# Notice of Decision

## Historic Review of Exterior Alterations and Use of Substitute Materials

HI-25-24

Type of Application:	Historic Review of Use of Substitute Materials for replacement of seven wooden porch columns with fiberglass columns.
Review Body:	Landmarks Commission (Type III review)
Property Owner:	Tom Klaus, 910 6th Avenue SW; Albany, OR 97321
Applicant:	Brent Mosser c/o TNT Builders, 620 Queen Avenue SW, Albany, OR 97322
Address/Location:	910 6th Avenue SW Albany, OR 97321
Map/Tax Lot:	Linn County Tax Assessor's Map No. 11S-04W-12AA-09600
Zoning:	Hackleman Monteith (HM)
Overlays:	Monteith National Register Historic District

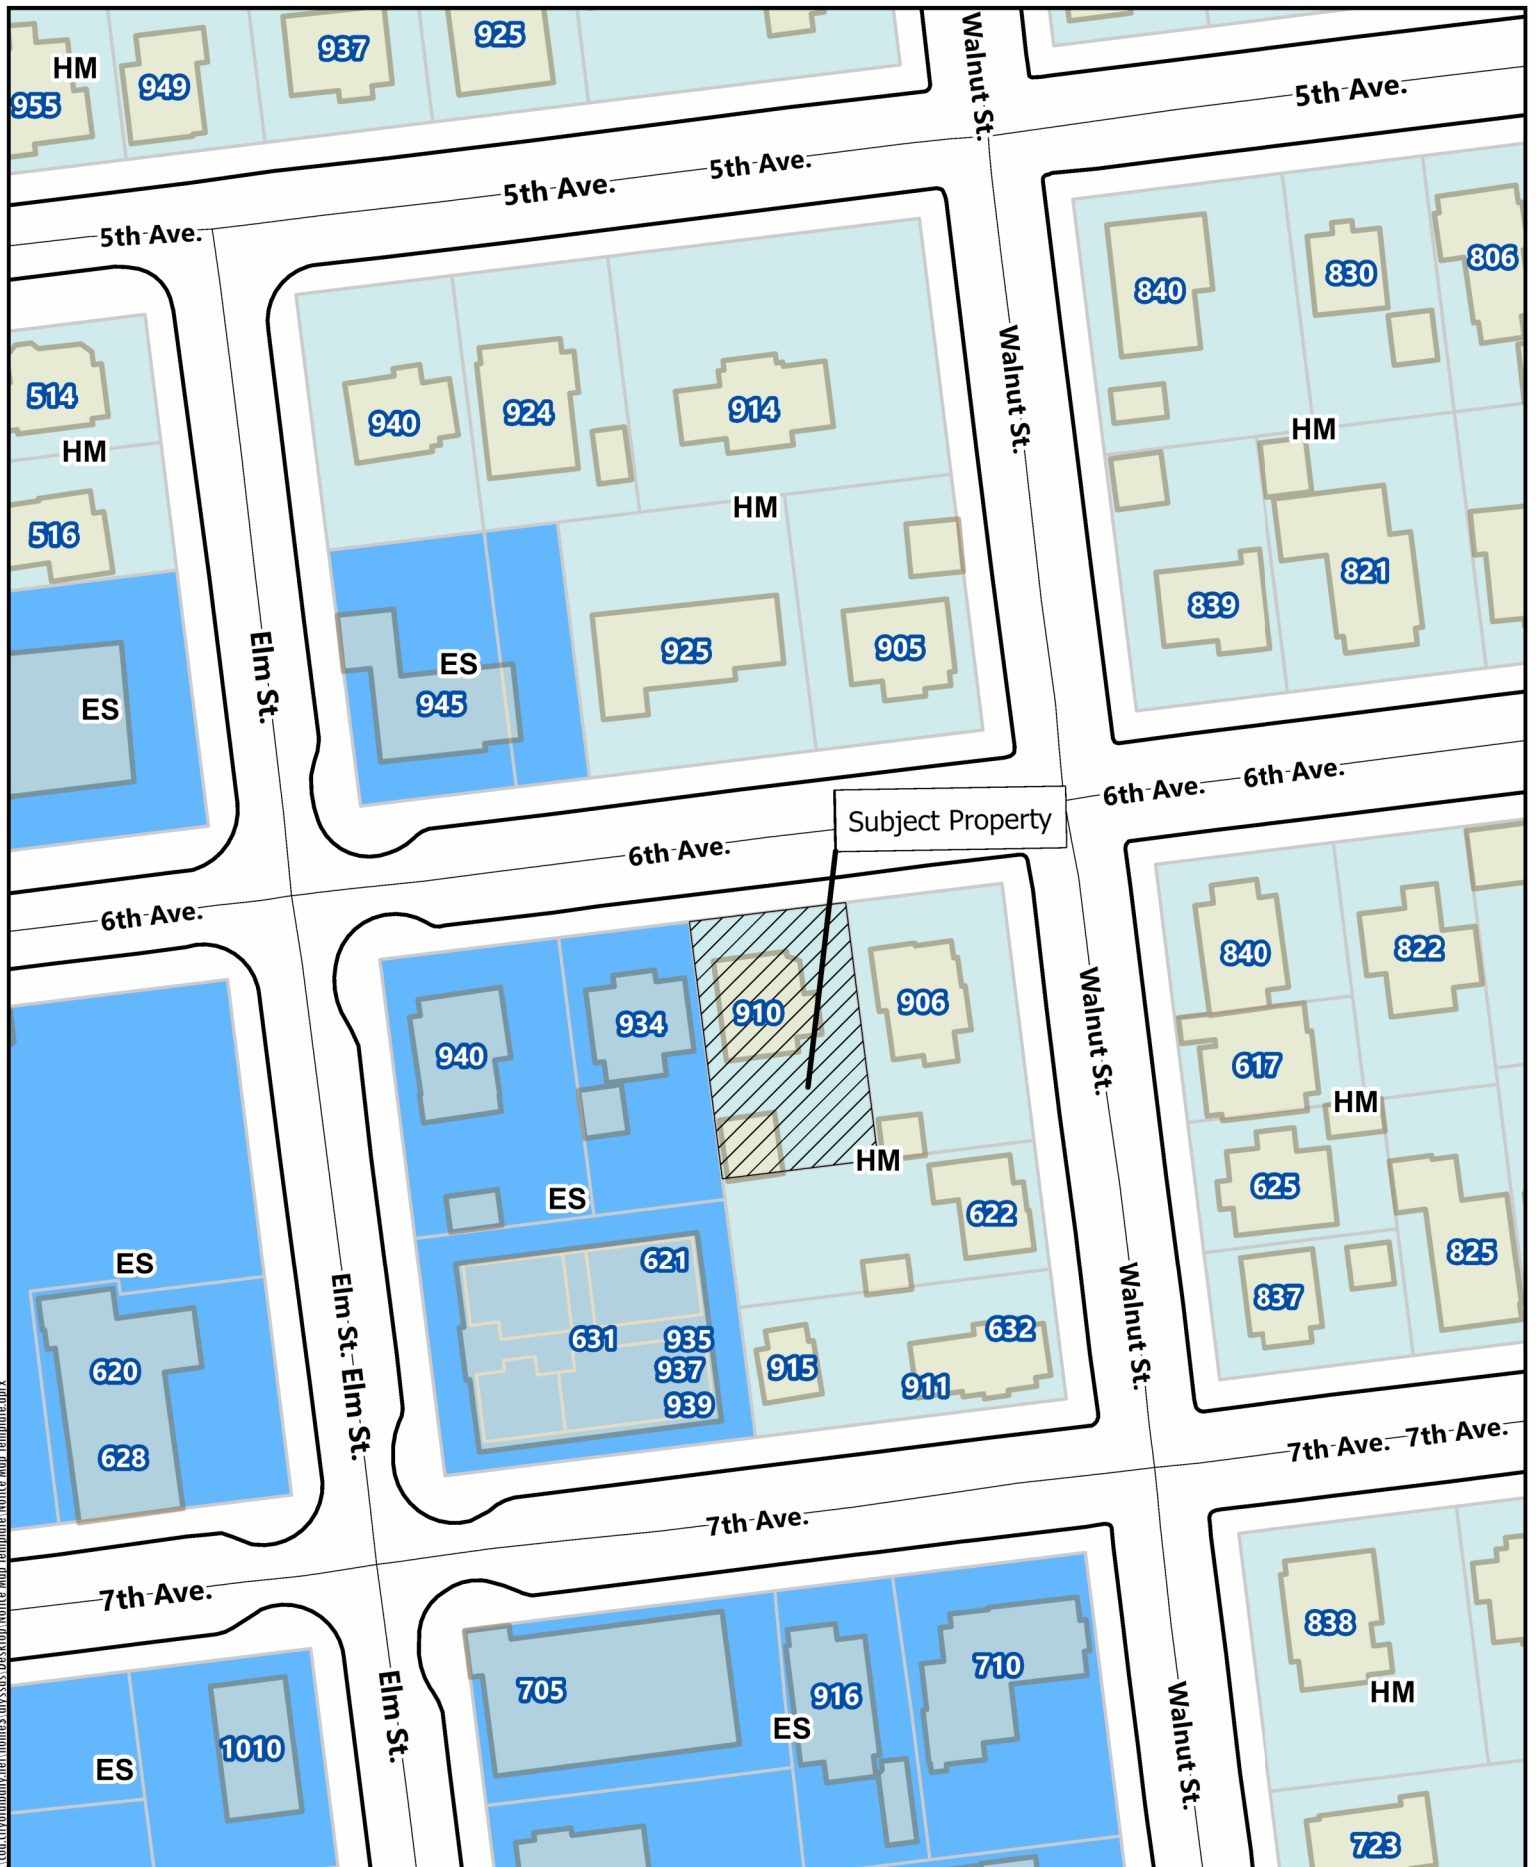
**Condition 3 Use of Substitute Materials** – The two original front columns on the structure are not approved to be replaced under this review (see image below for reference).
